P23-23
Acme Preliminary Plan

Property Owner: Albrecht Incorporated
 Applicant: Greg Ernst
 Location: Northwest Corner of Wooster Pike and High Point Drive (Parcel #028-19C-20-153)
 Zoning: SPD-1 (Special Planning District) with Underlying C-3 (General Commercial)
 Request: Preliminary Plan approval for a grocery store with a pharmacy drive through

1
sp2.1
SITE PLAN - PHASE 1
SCALE: 1" = 40'-0"
NORTH

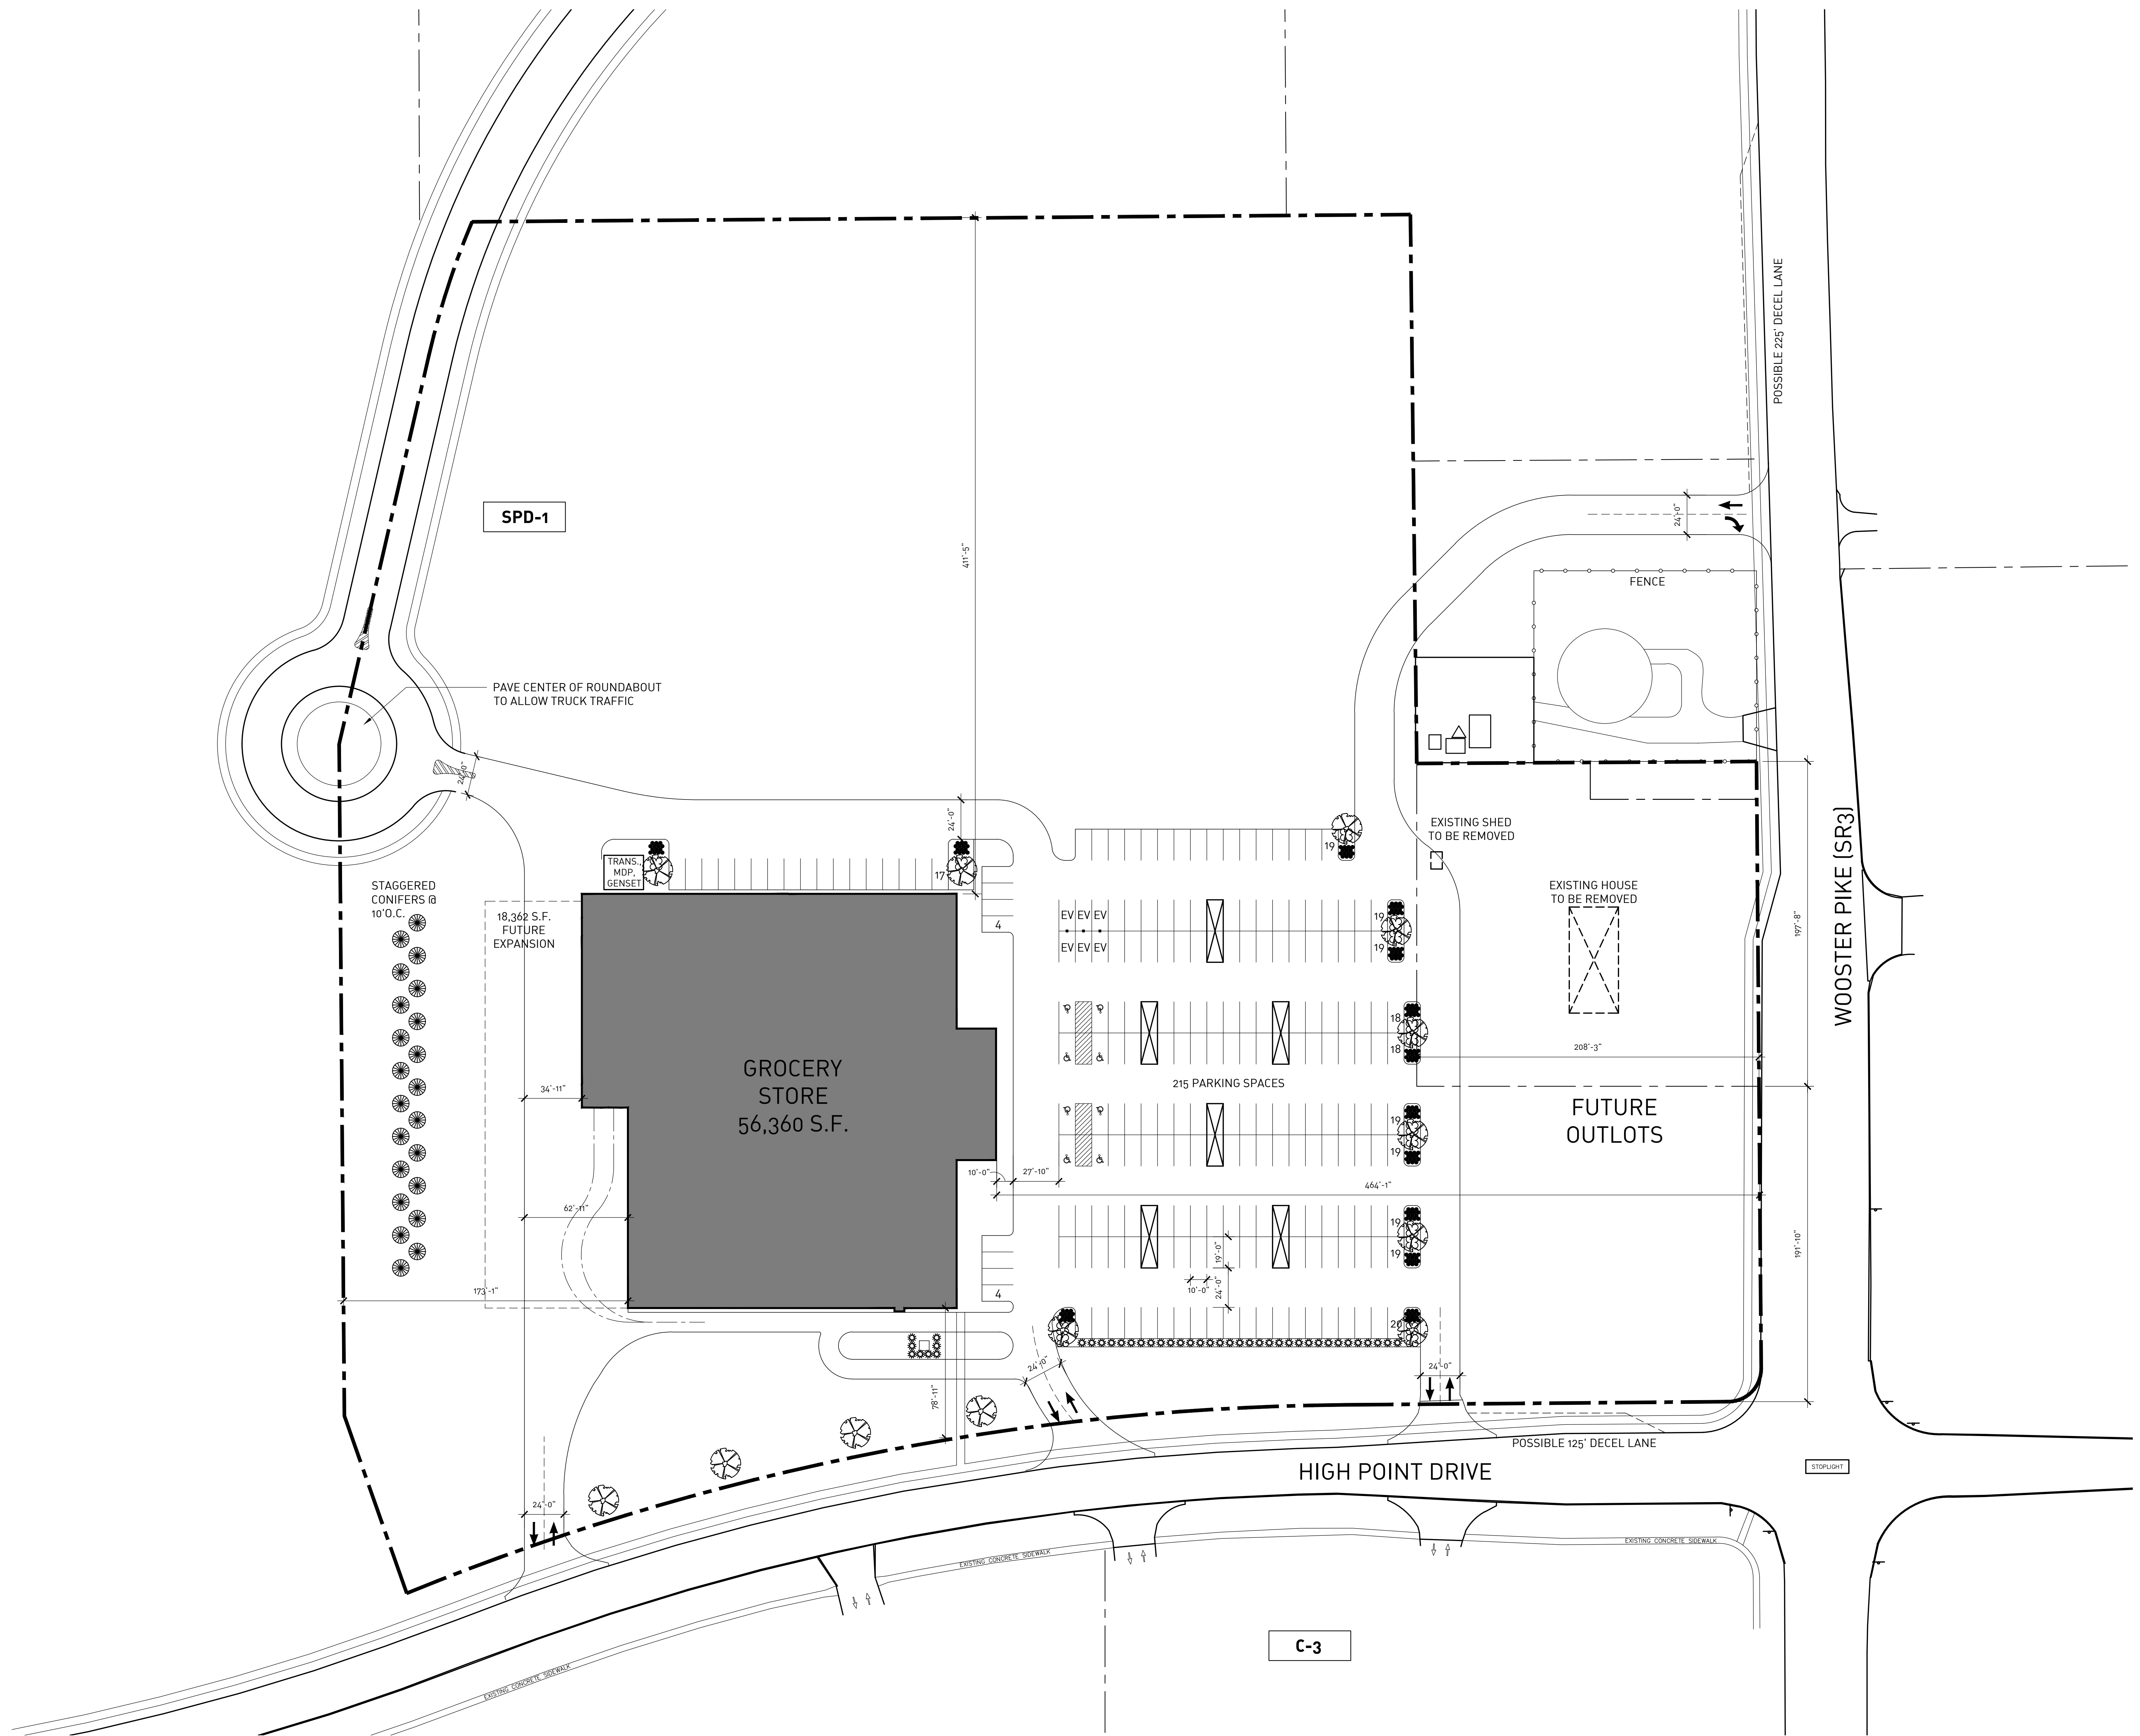
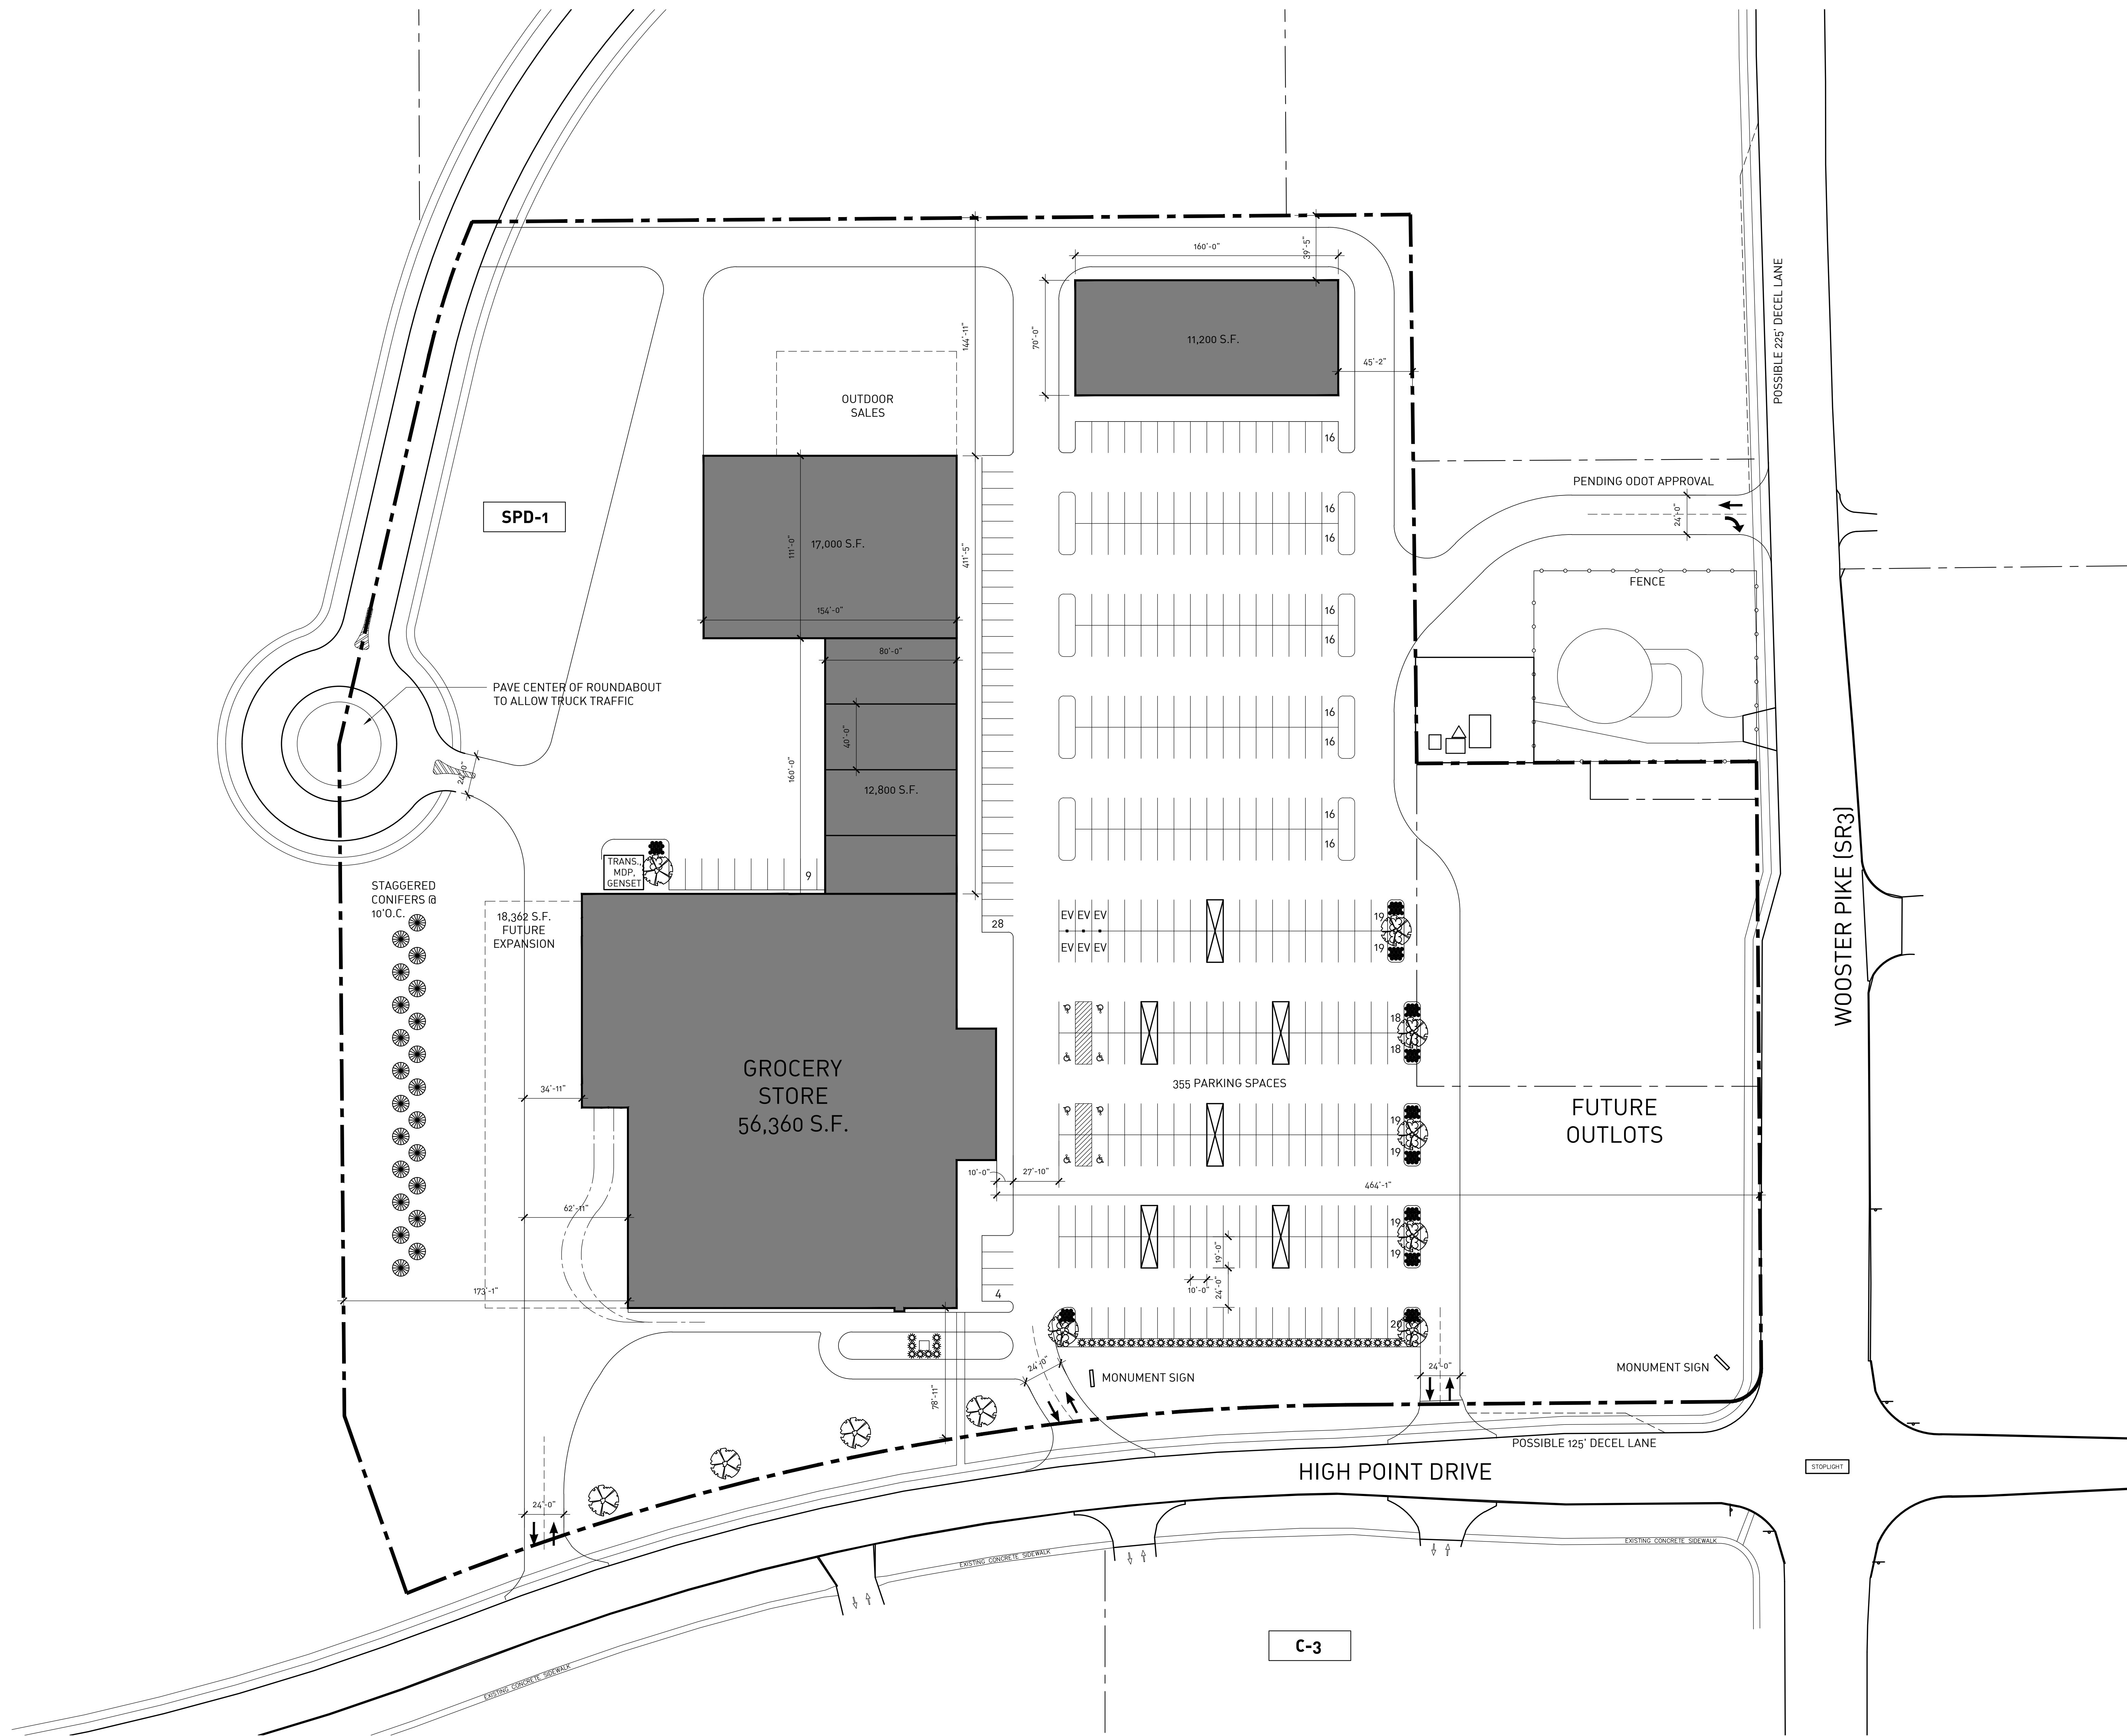
Access Drive Width – Access Drives are permitted to be up to 24 ft. in width at the right-of-way and 38 ft. in width at the curb. This standard does not apply to an access drive on Wooster Pike, which is not under city jurisdiction, and the access drive on Mast Parkway, which is existing. Access drives on High Point Drive are shown at 24 ft. in width at the right-of-way, however, the drives are 80 ft. in width at the curb.

The proposed site incorporates 219 total parking spaces, which exceeds the maximum indicated. However, the proposed parking lot appears to be appropriate for the project. In addition, “Phase 2” of the development will reduce parking on the north side of the grocery store and will result in shared parking between future inline tenants and the grocery store.

One follow up question. Access Drives are permitted to be up to 24 ft. in width at the right-of-way and 38 ft. in width at the curb. Access drives on High Point Drive are shown at 24 ft. in width at the right-of-way, however, the drives are 80 ft. in width at the curb.

Typically, this would be a variance. However, since this is a "Special Planning District" (SPD), it has its own Development Text. So they will either need to comply with the requirement or indicate in the Development Text that 80 ft. in width at the curb is permitted.

I am fine with the 80 foot for the entrance that will be primarily for truck deliveries, but 80 foot is probably a little wide for the other entrances. As a comparison, for our own street projects we typically use a 25 foot radius on residential streets. Since the pavement is 25 foot wide, that would equate to a drive width of 75 feet at the intersection. I think 75 feet is sufficient and would support it for the non-truck access drives.

All that being said, 80 foot is really not that much more, so I wouldn't have a big problem with that, but I would prefer 75 foot just for consistency.

2 SOUTH ELEVATION
SCALE: 1/8" = 1'-0"

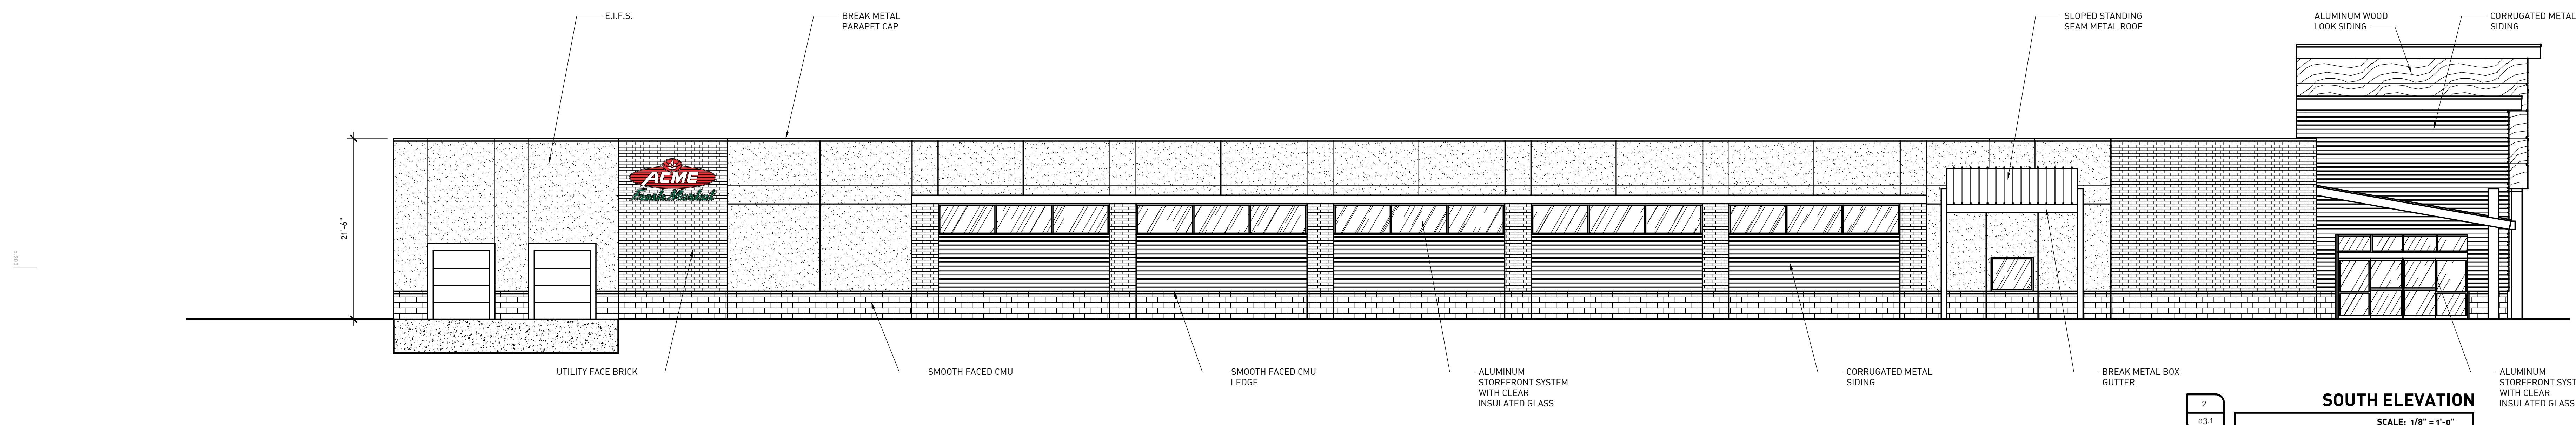
- The south side of the building incorporates brick, smooth faced CMU, E.I.F.S., and metal siding. The side of the building includes a central area with projecting brick columns, windows, and a mix of materials. A sloped metal roof is present near the southeast corner of the building over the pharmacy pickup window.

Building elevations show 5 wall signs, which appear to be in compliance with area requirements, however, the pharmacy drive through sign cannot be located on a roof. Freestanding signs for the development have not been shown at this time and will need to be included with the Final Site Plan.
